RENESAS TECHNICAL UPDATE

| Product Category | MPU & MCU | | Document No. | TN-RX*-A111A/E | Rev. | 1.00 |
| Title | Corrections to User's Manual regarding the FASR.EXS bit for the Flash Memory in the RX111 Group | | Information Category | Technical Notification | | |

This document describes corrections to the description for the FASR.EXS bit in section 35. Flash Memory of RX111 Group User's Manual: Hardware Rev.1.10.

Figure 35.13 Procedure to Issue the Block Erase Command for the E2 DataFlash

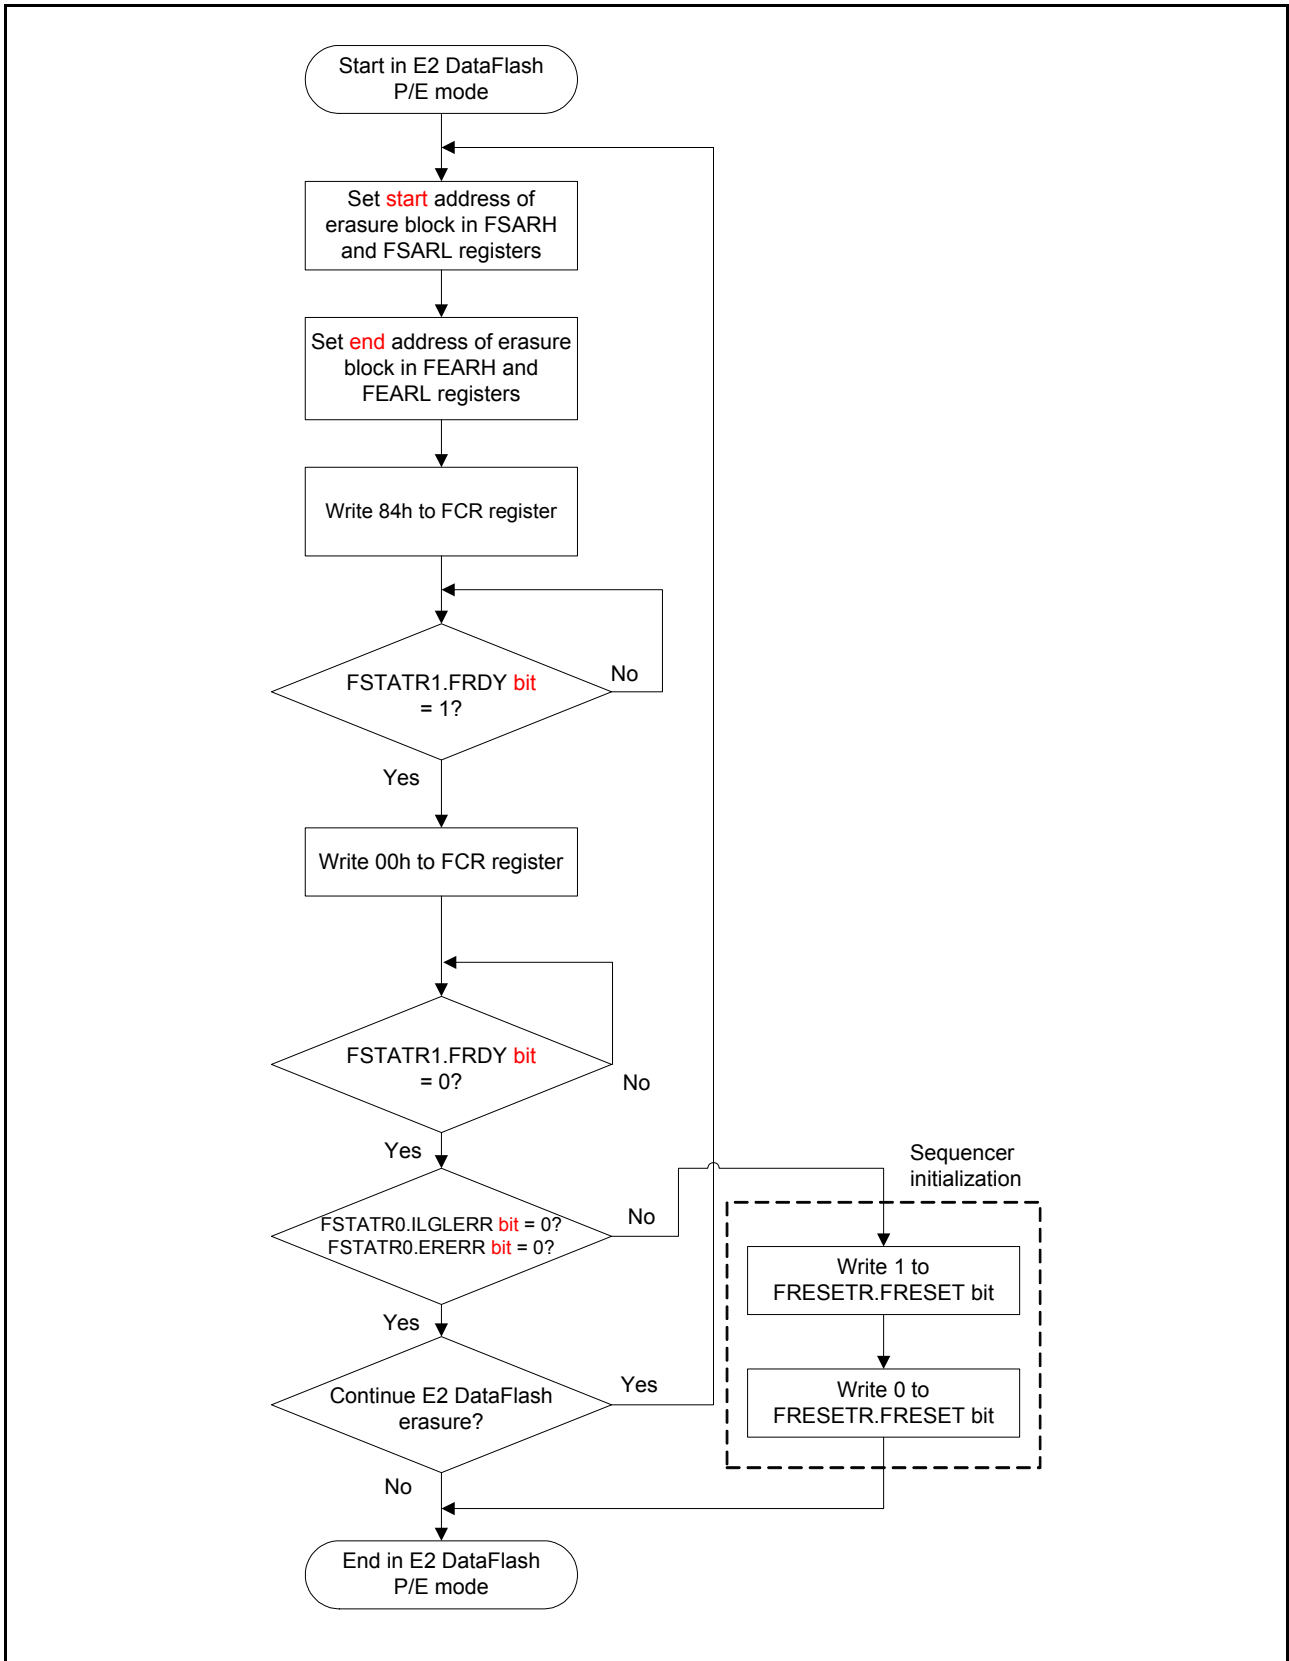
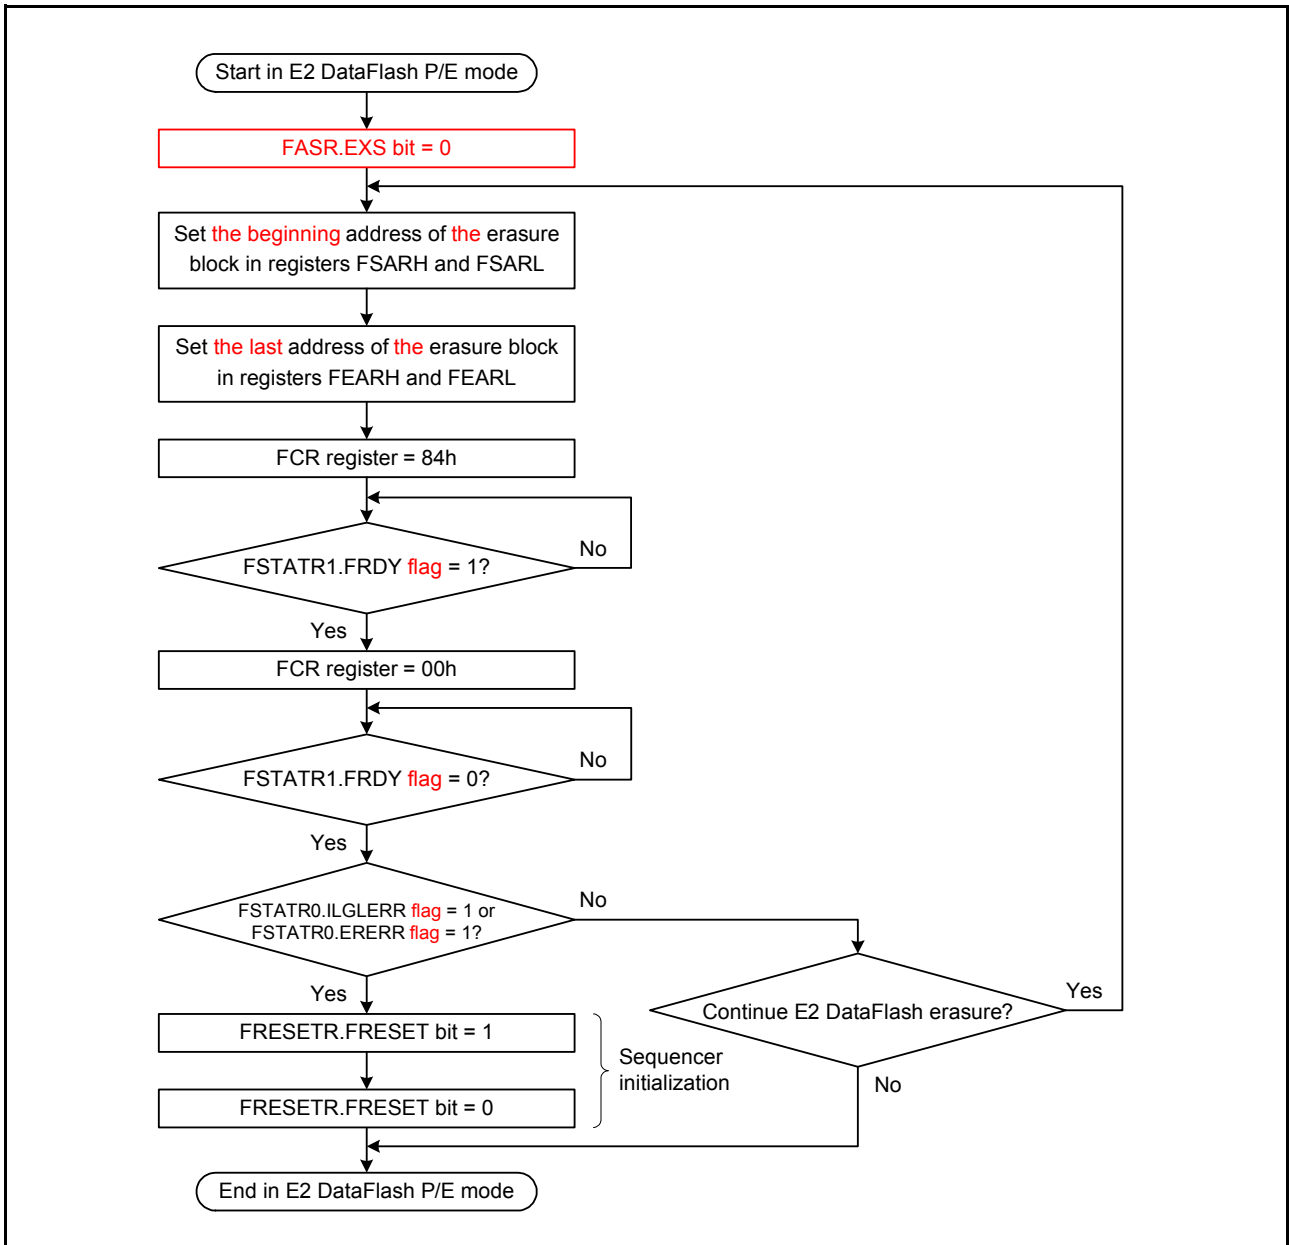
Figure 35.13 in (3) Programming and Erasure Procedures of 35.7.3 Software Command Usage is corrected as follows:

Figure 35.14 Procedure to Issue the Blank Check Command for the ROM

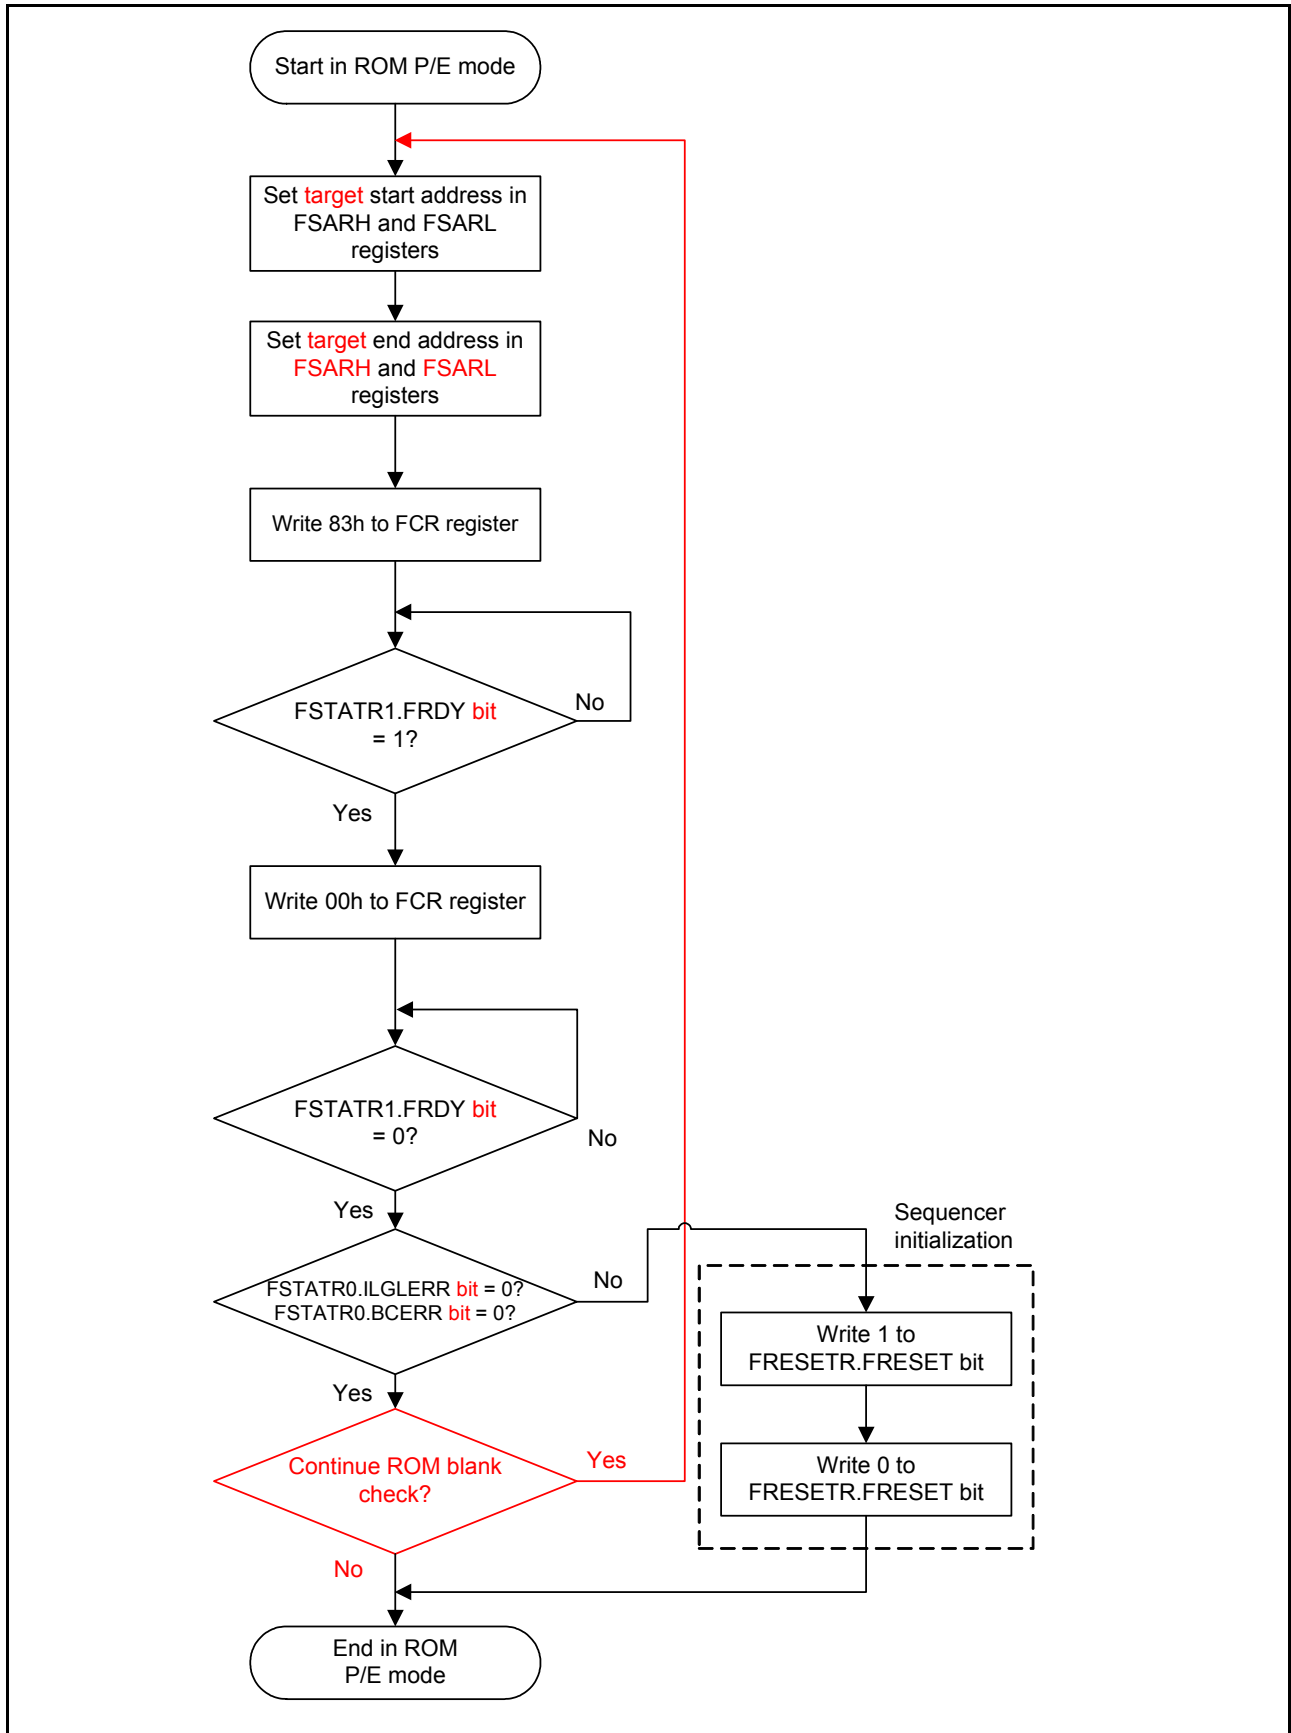
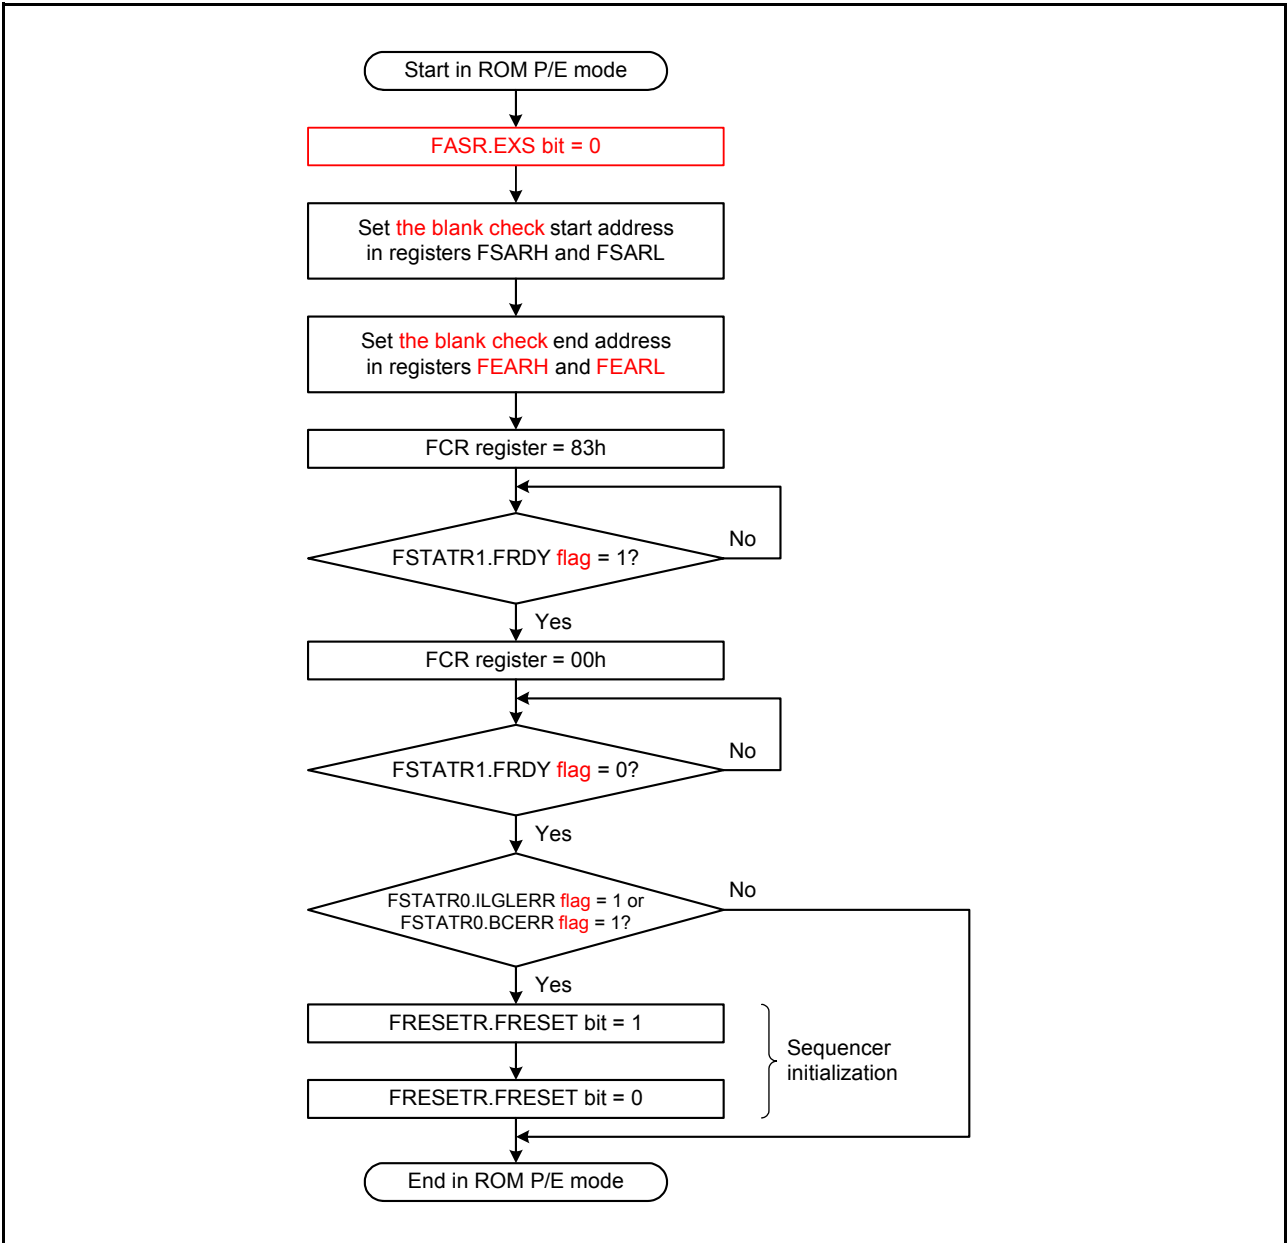
Figure 35.14 in (3) Programming and Erasure Procedures of 35.7.3 Software Command Usage is corrected as follows:

Figure 35.15 Procedure to Issue the Blank Check Command for the E2 DataFlash

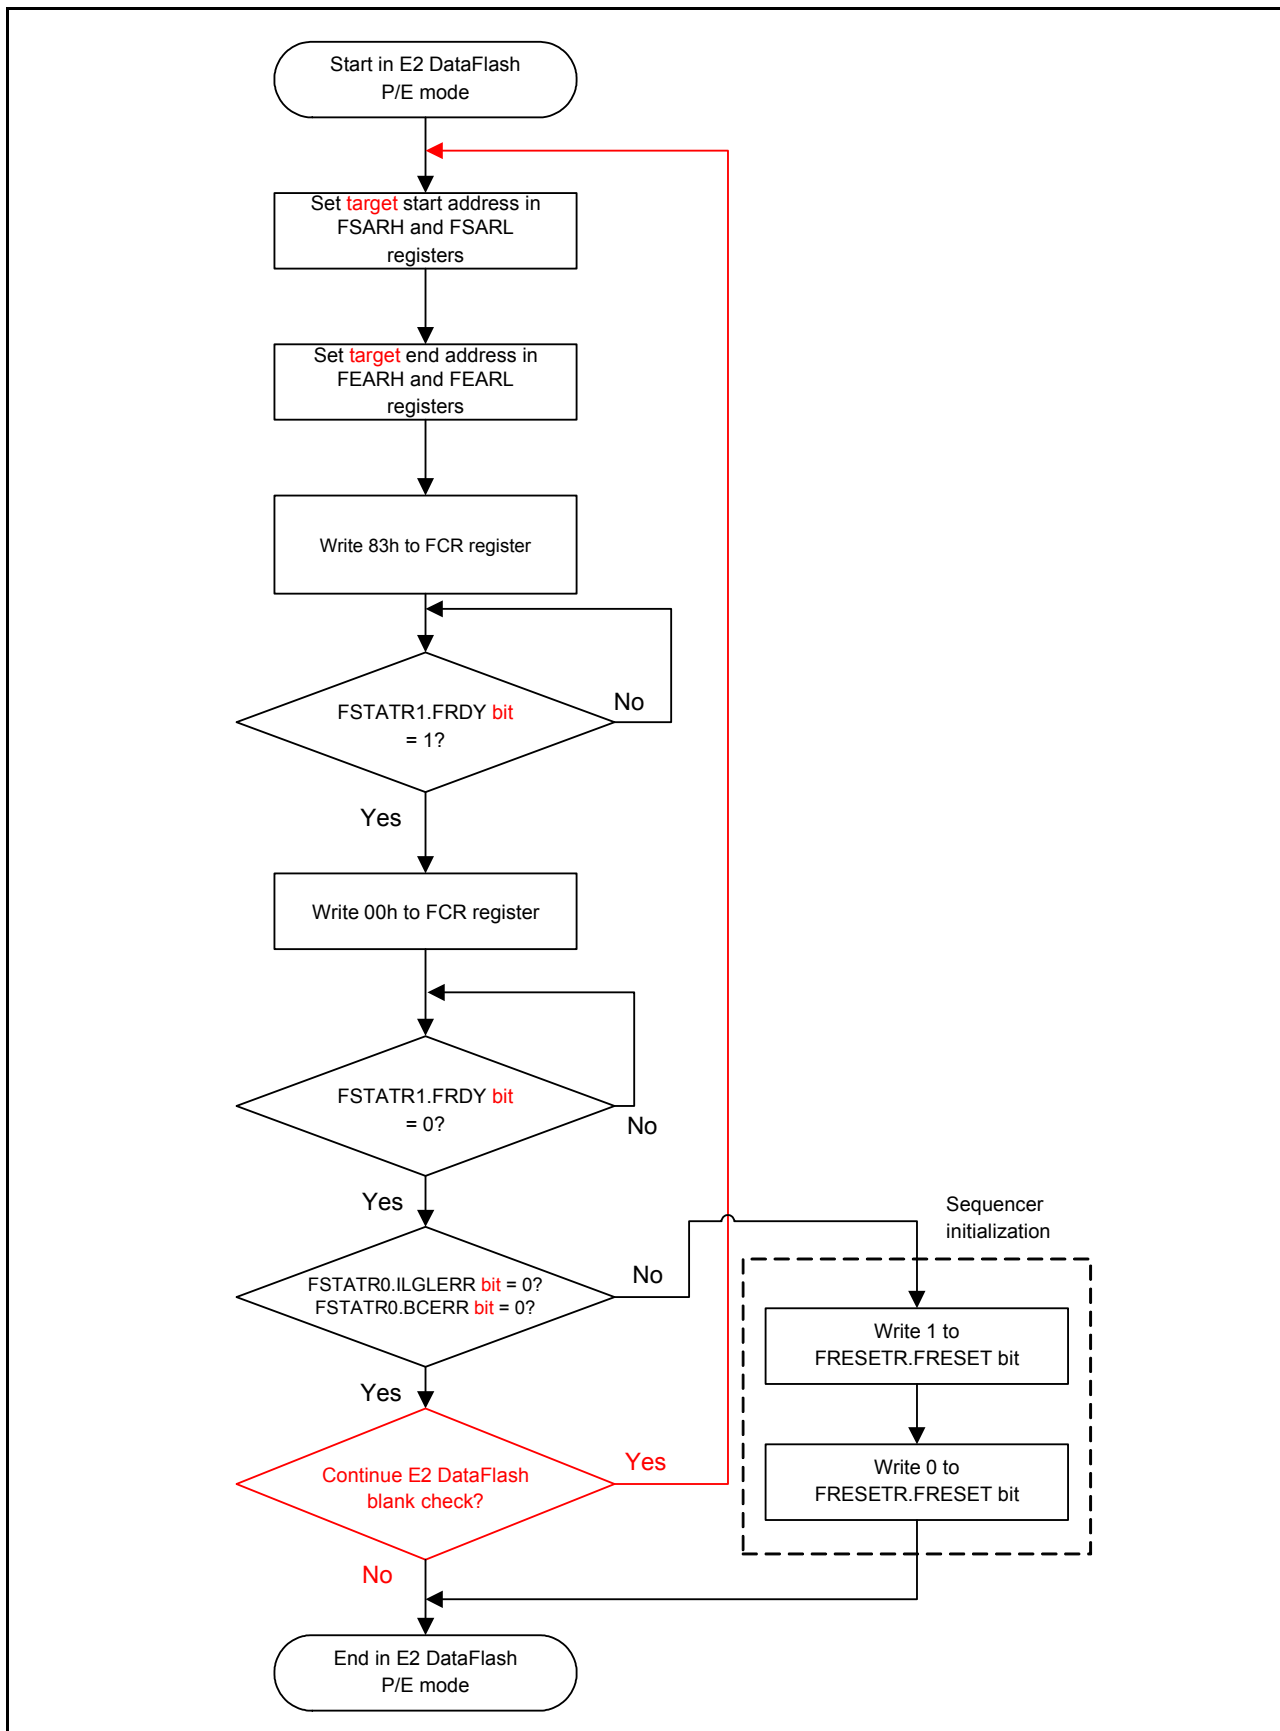
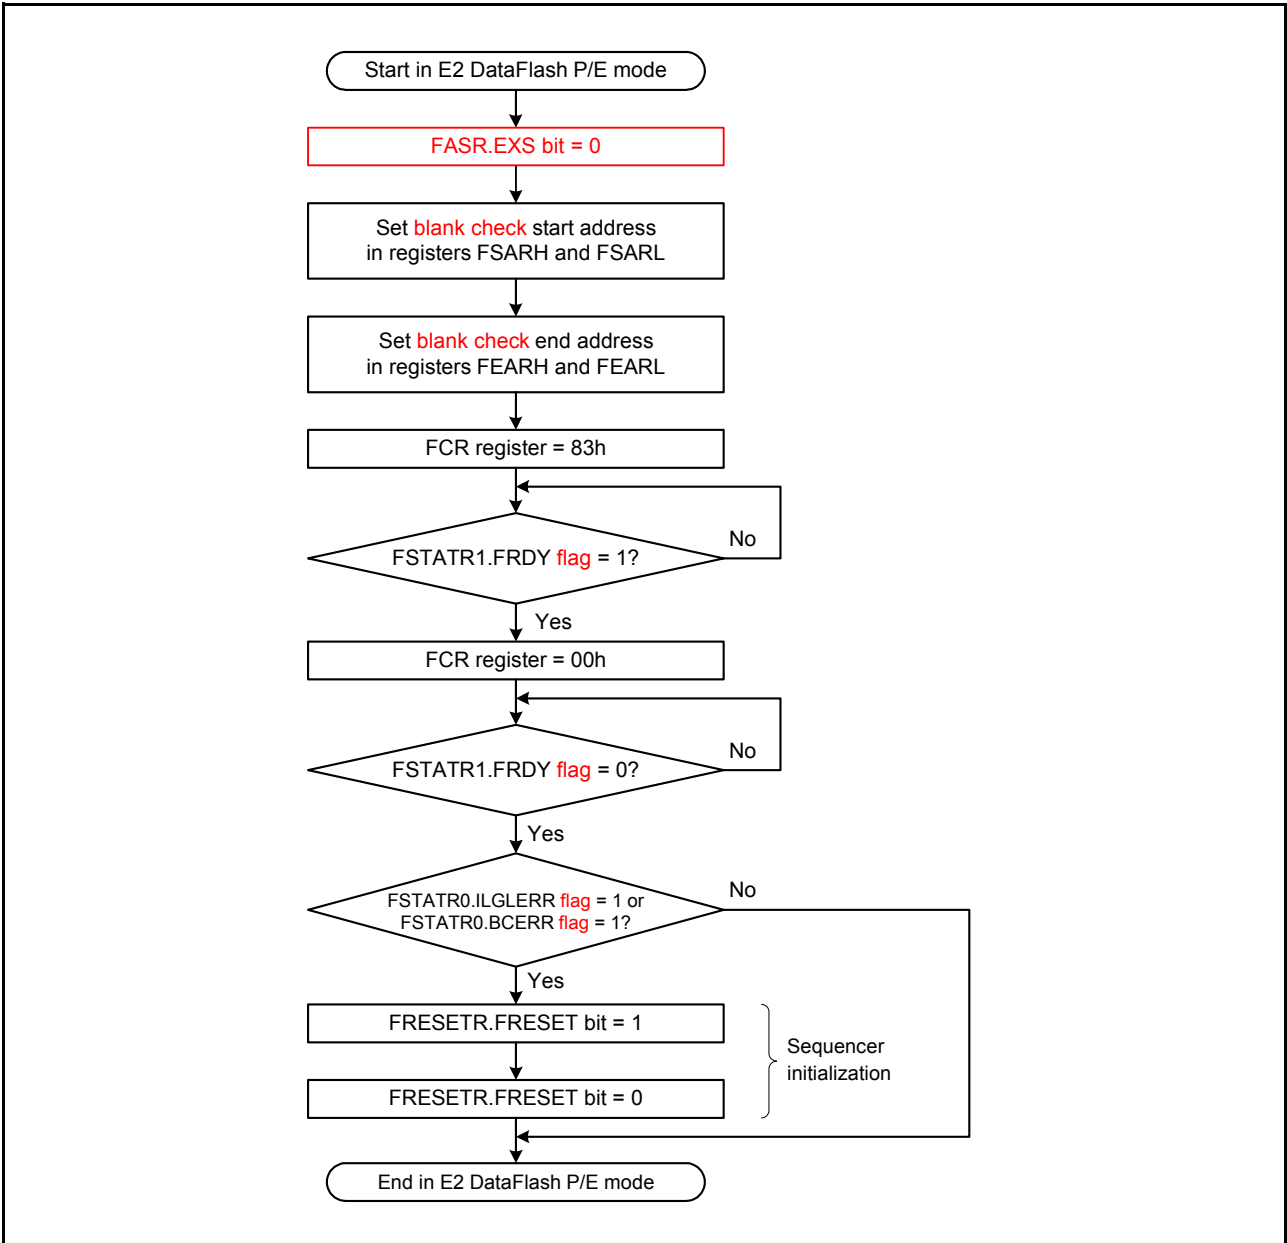
Figure 35.15 in (3) Programming and Erasure Procedures of 35.7.3 Software Command Usage is corrected as follows:
